PROJECT NAME
CHILDREN'S HOSPITAL OF ORANGE COUNTY
455 S. Main St.
Orange, CA 92668-3874

TOWER II

DRAWING TITLE
LEVEL 1 REFLECTED CEILING PLAN AREA - A

DRAWING NUMBER
A4.1A

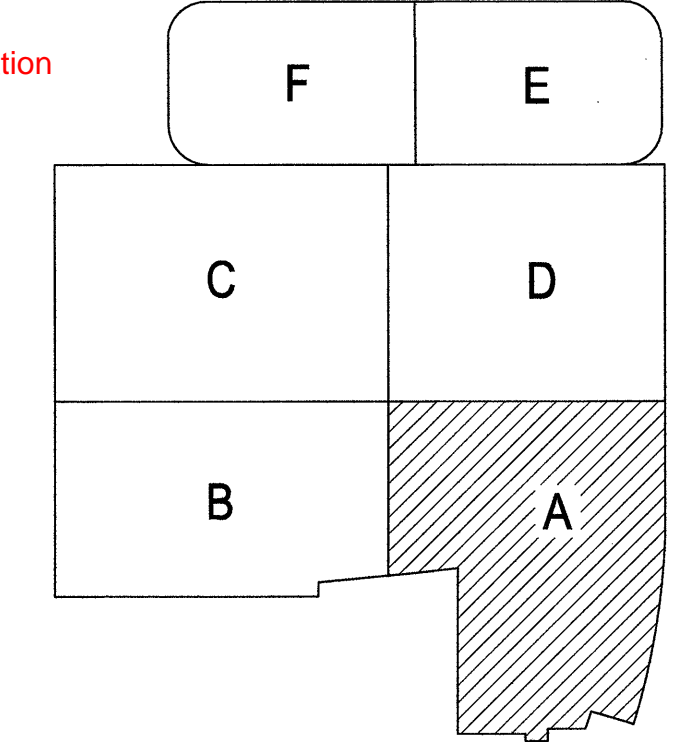
RFI 4014
See revised ceiling layout per access panel coordination.

B2 ENLARGED PLAN

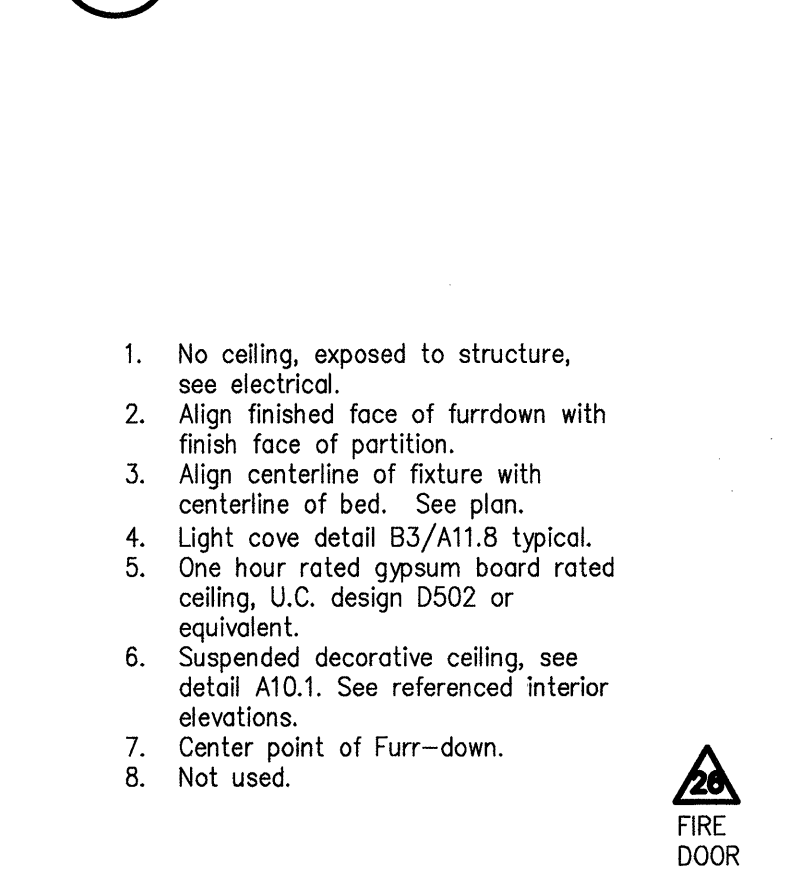
RFI #5473
RCP Coordination level 1.
